UNITED STATES
NUCLEAR REGULATORY COMMISSION
WASHINGTON, D.C. 20555-0001

SUBJECT: PERRY NUCLEAR POWER PLANT, UNIT 1 – SAFETY EVALUATION
REGARDING IMPLEMENTATION OF MITIGATING STRATEGIES AND
RELIABLE SPENT FUEL INSTRUMENTATION RELATED TO ORDERS
EA-12-049 AND EA-12-051 (CAC NOS. MF0962 AND MF0802)

PERRY NUCLEAR POWER PLANT, UNIT 1

[PNPP SFP Datum Value Sketch]

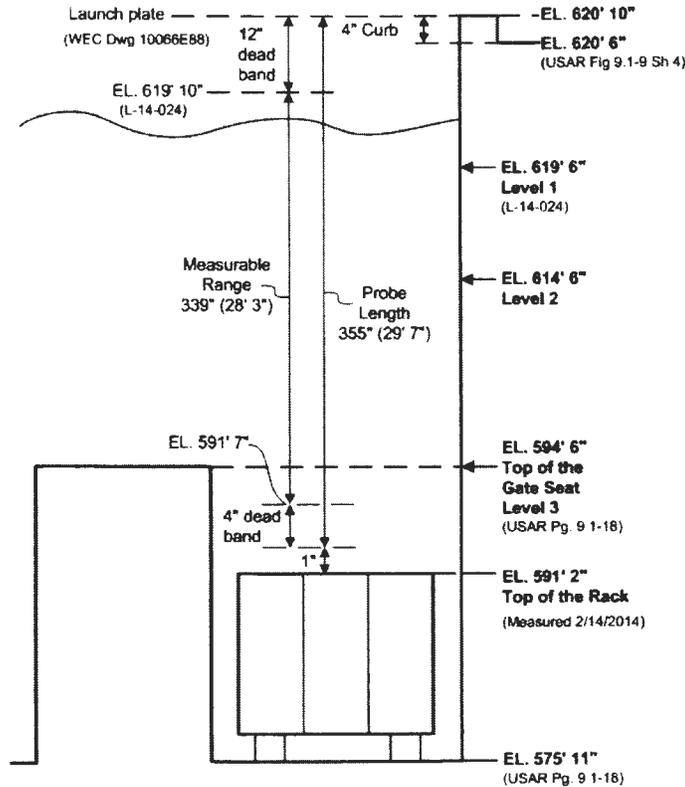
Level 2 was previously set as the indicated level on either the primary or backup instrument channel of greater than elevation (EL) 601' 4" plus the accuracy of the SFPLI channel which was to be determined. This level was selected based on the NEI 12-02, Revision 1, guidance for selecting the plant specific elevation for Level 2 given as 10 feet

(+/- 1 foot) above the highest point of any fuel rack seated in the SFP. This level provides adequate radiation shielding for a person standing on the SFP operating deck from the fuel in the pool; however, the PNPP SFP contains other materials capable of providing sufficient dose such that the pool deck would not be inhabitable should the materials be uncovered. To support the development of diverse and FLEX procedures, a site-specific radiation calculation was performed to determine a more appropriate Level 2 as it applies to FLEX mitigation strategies. As provided for in NEI 12-02, Revision 1, the calculation considered the emergency conditions that may apply at the time and the scope of necessary local operations, including installation of portable SFP instrument channel components. As a result, Level 2 has been reestablished as EL 614' 6".

In its compliance letter dated June 2, 2015 [Reference 44], the licensee provided a revised sketch showing Levels 1, 2, and 3, reproduced below:
